WALSH BAY ARTS AND CULTURAL PRECINCT

RESPONSE TO SUBMISSIONS

APPENDIX 3: SUPPLEMENTARY TRANSPORT REPORT

RE: **Walsh Bay Arts and Cultural Precinct – Response to submissions – Traffic, transport, access and parking**

WALSH BAY ARTS AND CULTURAL PRECINCT
PIER 02
LOADING DOCK
SWEPT PATH ASSESSMENT

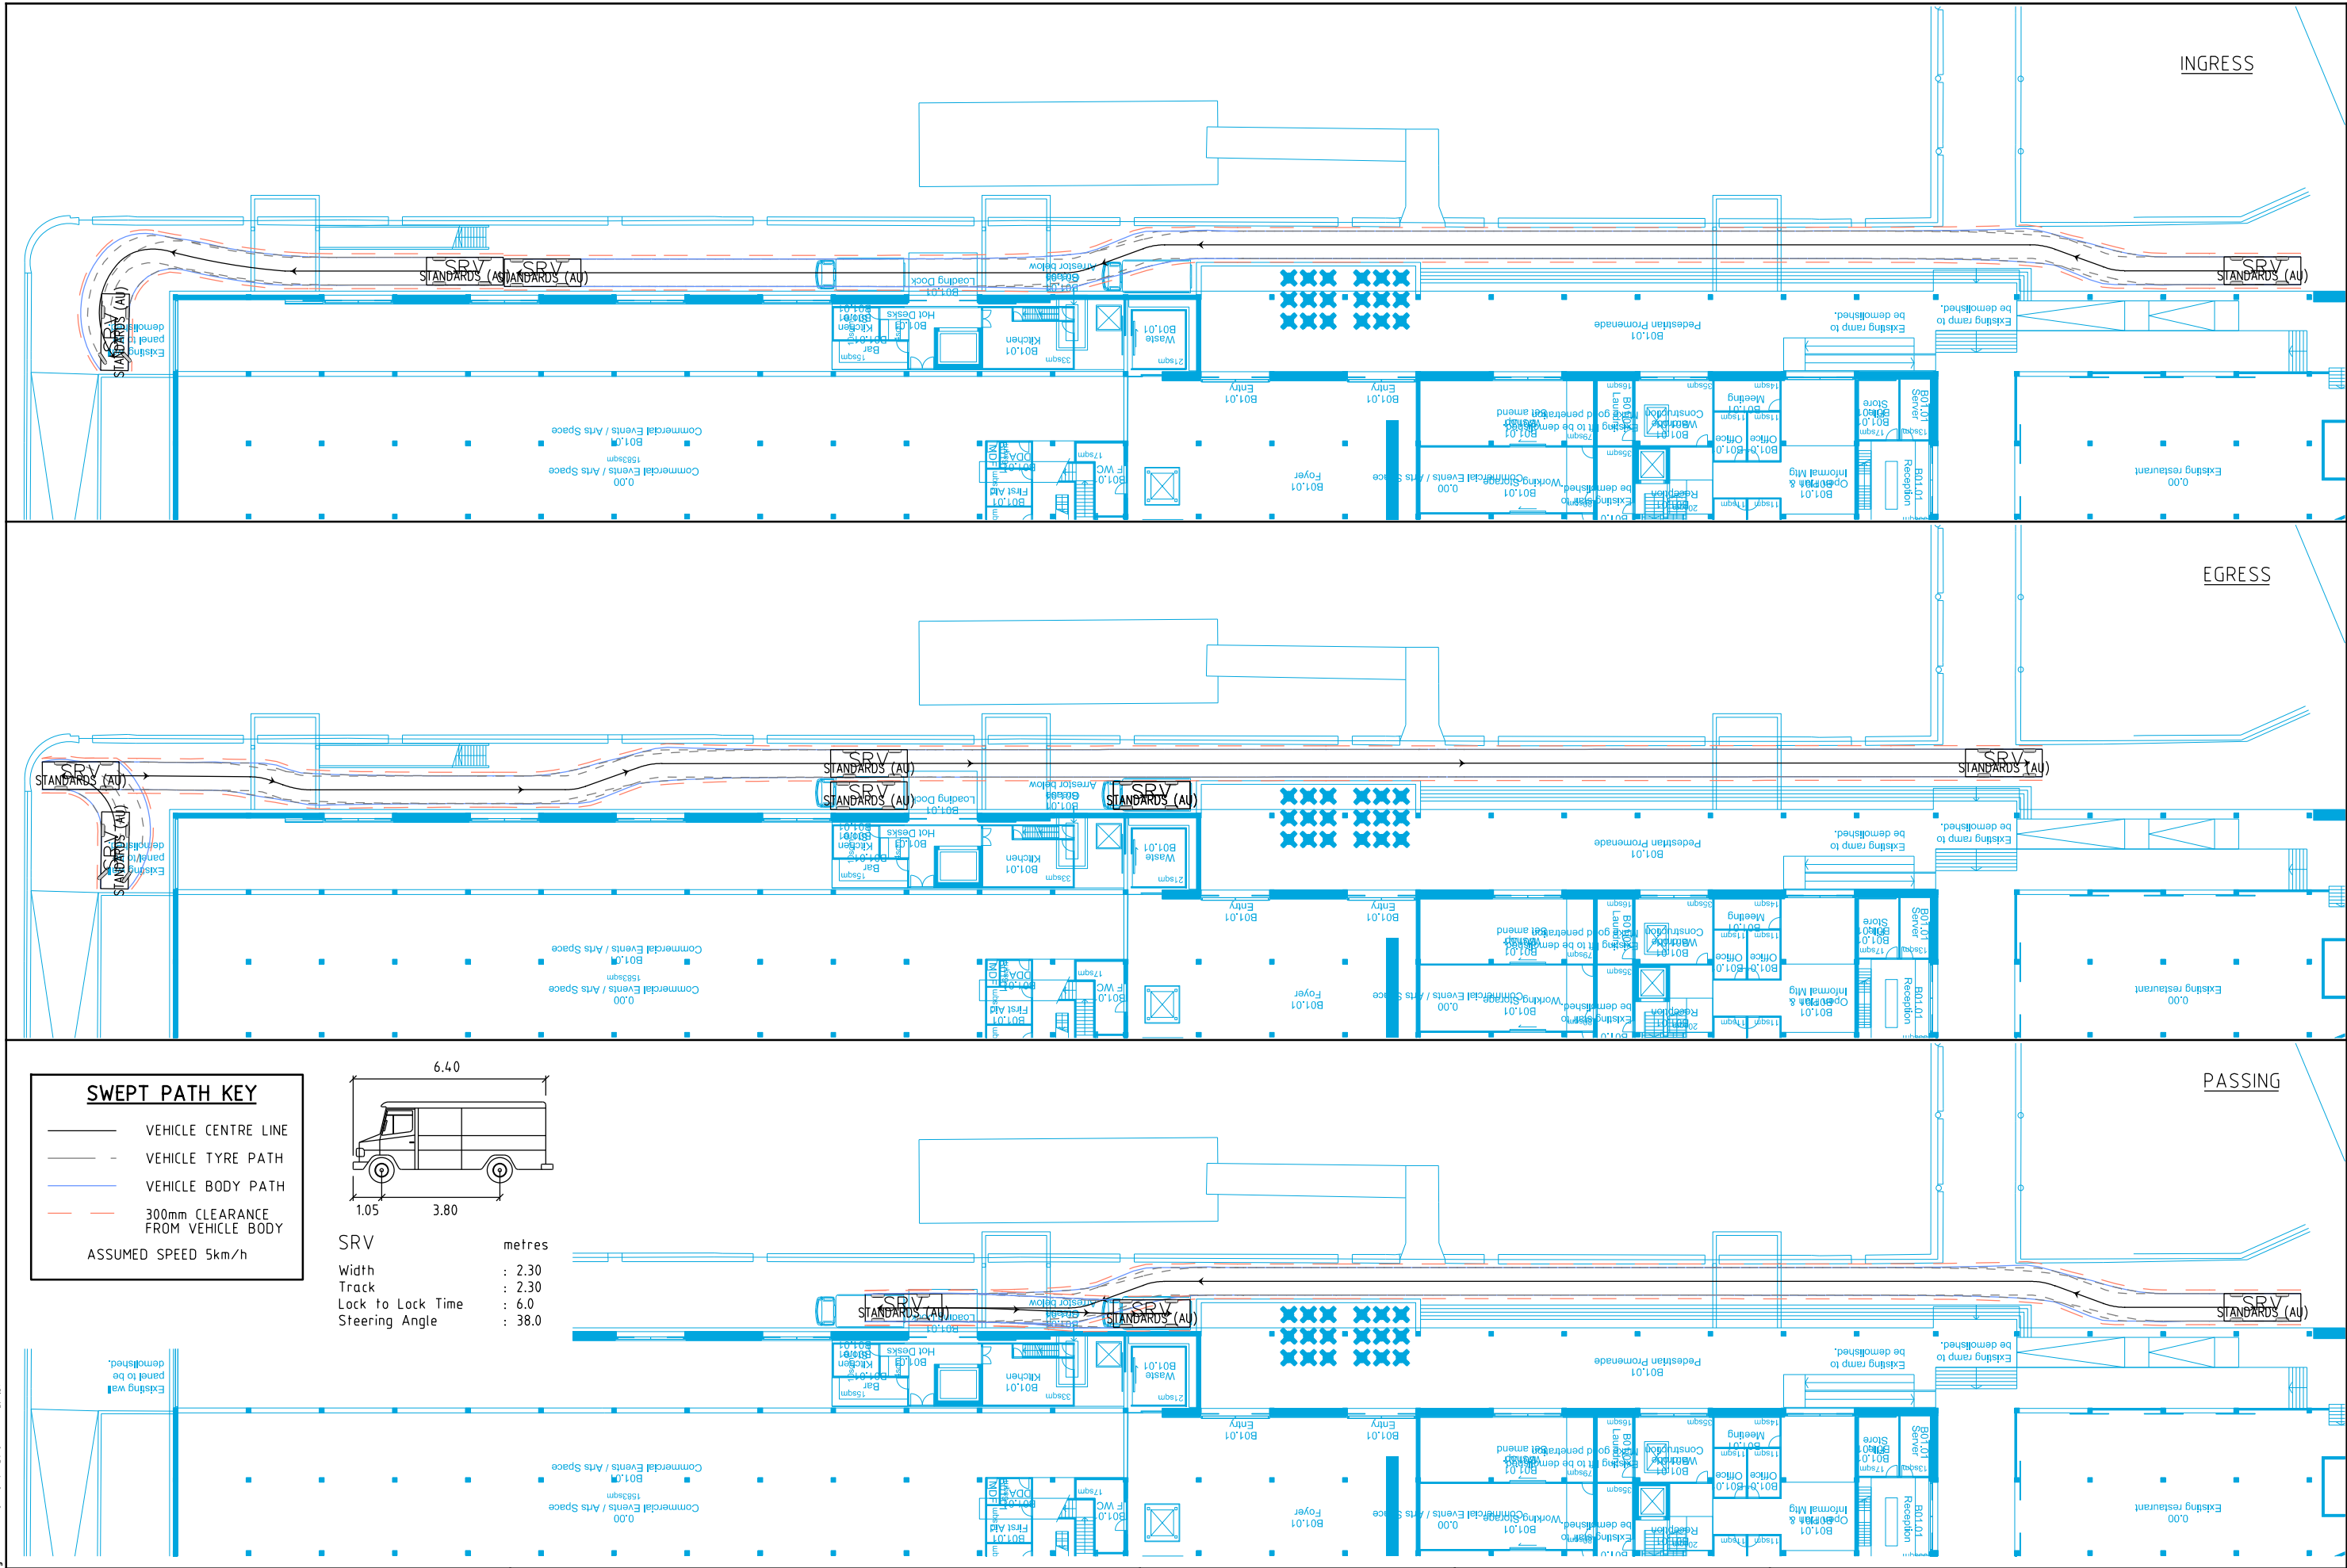
As the building is a heritage structure, no external modifications will be undertaken to retrofit loading dock facilities to meet the relevant Australian Standard. Nevertheless, the proposed loading dock has only a minor variance to the Australian Standards whereby the existing apron is generally 5.8 metres wide, compared with a requirement of 6.2 metres for two medium rigid (8.8-metre) vehicles to pass. The 5.8-metre width would allow for two small rigid (6.4 metres) vehicles to pass each other, with some localised constraints where services are located. Any passing movements would need to be undertaken with one vehicle parked hard up against the building or edge of the wharf and the other vehicle would be required to pass at low speed. This issue could be mitigated by ensuring that only one vehicle accesses the apron at any given time and during the detailed design phase, appropriate passing bay locations are identified to provide safe passing opportunities for instances when two vehicles are required to pass each other.

Swept paths have been undertaken and are provided at Attachment A of this report. The Applicant considers that no additional infrastructure works are required to the loading dock areas for the project.
